Notice of Allowability	Application No.	Applicant(s)
	10/710,788	STOLL ET AL.
	Examiner	Art Unit
	Dana Ross	3722
The MAILING DATE of this communication appears on the cover sheet with the correspondence address All claims being allowable, PROSECUTION ON THE MERITS IS (OR REMAINS) CLOSED in this application. If not included herewith (or previously mailed), a Notice of Allowance (PTOL-85) or other appropriate communication will be mailed in due course. THIS NOTICE OF ALLOWABILITY IS NOT A GRANT OF PATENT RIGHTS. This application is subject to withdrawal from issue at the initiative of the Office or upon petition by the applicant. See 37 CFR 1.313 and MPEP 1308.

Application/Control Number: 10/710,788 Page 2

Fig-5

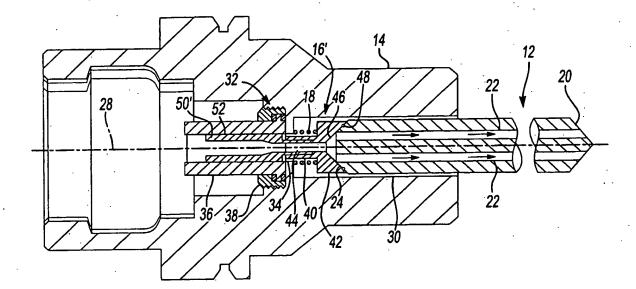
1. The drawing for Figure 5 showing a disclosed embodiment of Applicant's invention was received on 17 February 2006. This drawing are acceptable.
